JANNALI DEVELOPMENT

TCQ BUILDERS

PLANNING PROPOSAL AMENDMENTS (LP/06/376734)
MIXED USE - GEORGES RIVER ROAD [10_088]

CONCEPT PLANS: LEVEL 0 GROUND FLOOR

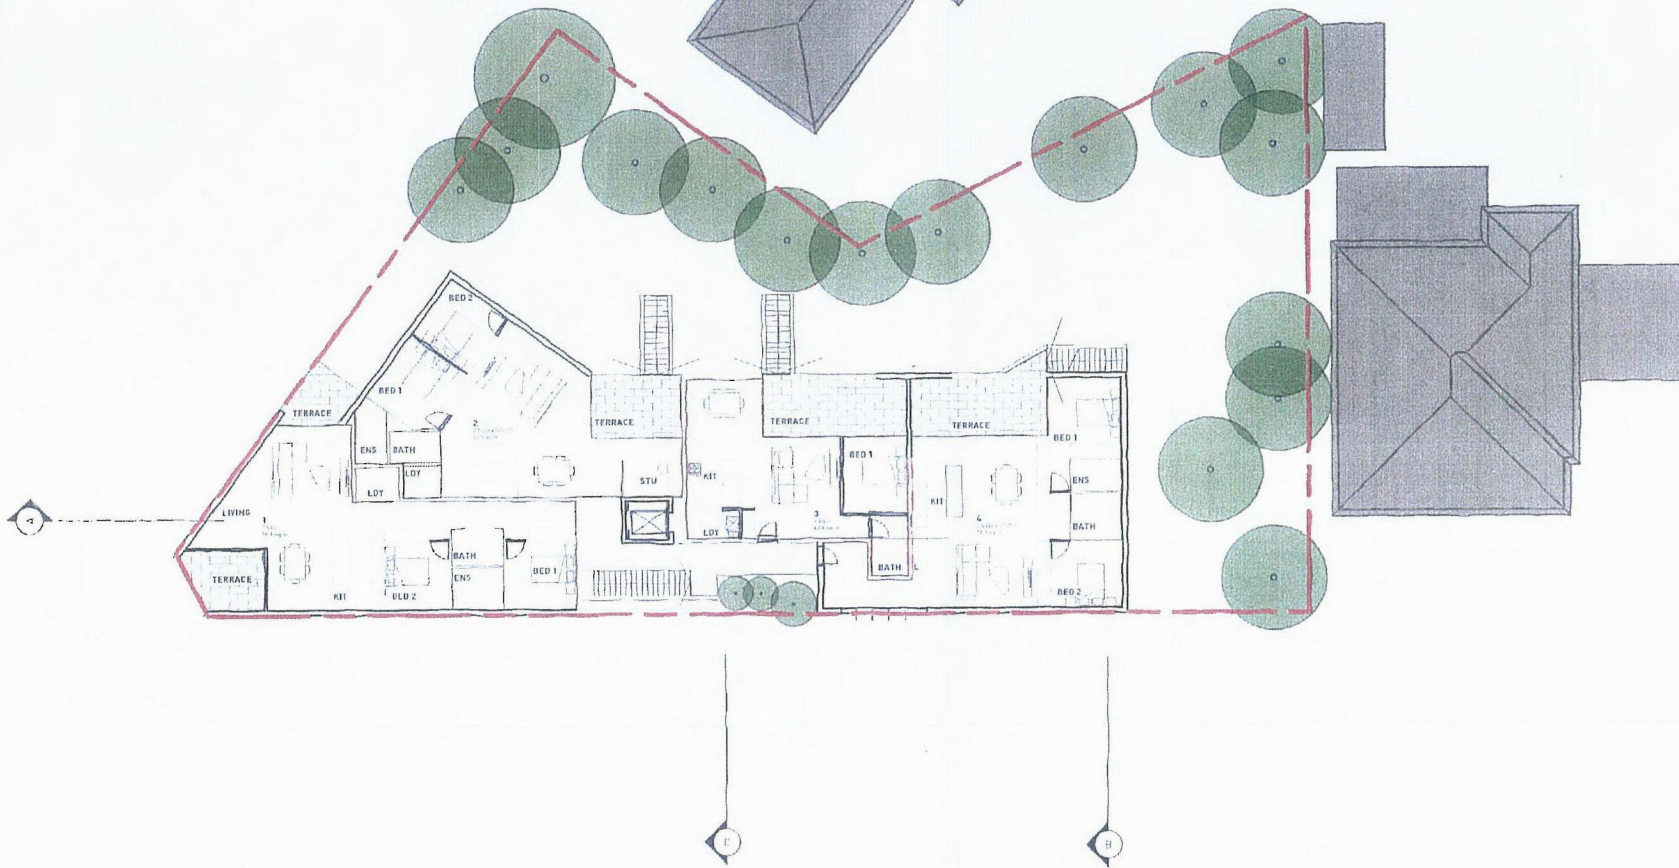
A preliminary plan of a medical centre layout is provided to demonstrate how active facades can be provided to Wattle Road and Georges River Road.
